A d d e n d u m

Iowa Department of Transportation
Office of Contracts

Date of Letting: June 19, 2012
Date of Addendum: May 30, 2012

B.O.	Proposal ID	Proposal Work Type	County	Project Number	Addendum
106	40-0204-049	PCC Pavement - Grade & Replace	Hamilton	NHSX-020-4(49)--3H-40	19jun106.a01

**RAMP TAPER SECTION
DETOUR PAVEMENT DETAILS**

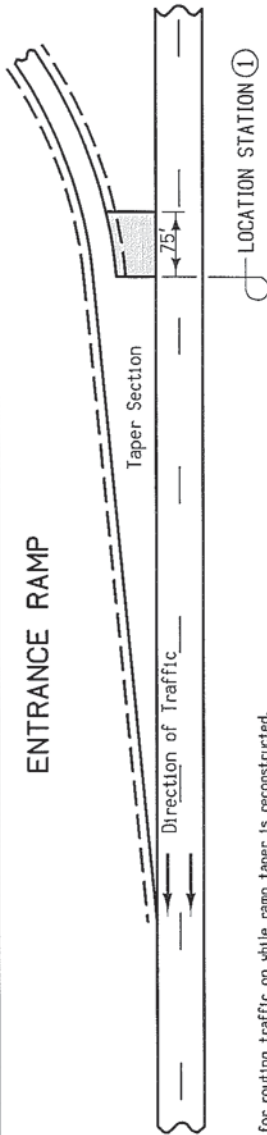
Make the following change to the Plan Sheet B.2:

Add attached Tab. DP-1 ENTRANCE RAMP:

Note:
Detour pavement is for routing traffic on while ramp taper is reconstructed.
Remove detour pavement when ramp taper reconstruction has been completed.

DETOUR PAVEMENT OPTIONS: 9" PCC or 12" HMA

LOCATION		DETOUR PAVEMENT Sq. Yds.	CLASS 13 EXCAVATION		SPECIAL BACKFILL Cu. Yds.	REMARKS
INTERCHANGE	RAMP ①		Cu. Yds.	Cu. Yds.		
US 20/1A 17 E. Jct.	325+00 Div. 1	208	87	35	Ramp D (EB Entrance Ramp) Place special backfill at a depth of 6" beneath the detour pavement.
